Access Compliance Report

Public Rights-of-Way

(Pedestrian Signals)

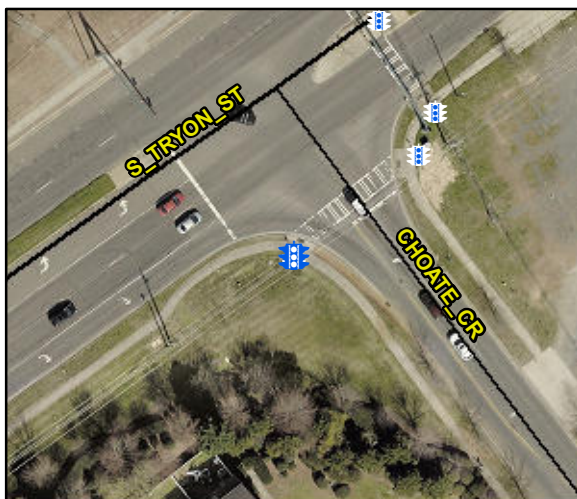
Surveyor Notes: TEXT HT 1/2

PROW/ADA: R410.6, TMUTCD 4e.08, R404.2, R404.7.3

Yes	B 1 Clear Xing Direction?	ClearlyMarked	N/A	B 2 Clear Xing Direction?	N/A
	B 1 Crossing Direction	To NE		B 2 Crossing Direction	N/A
Yes	B 1 DistanceTo XWalk (in)	3.0	N/A	B 2 DistanceTo XWalk (in)	N/A
No	B 1 DistanceTo Curb (in)	132.0	N/A	B 2 DistanceTo Curb (in)	N/A
Yes	B 1 Diameter (in)	2.0	N/A	B 2 Diameter (in)	N/A

Possible Solutions: Replace Signal Push Button With APS Button on New Post. Remove & Replace Sign.
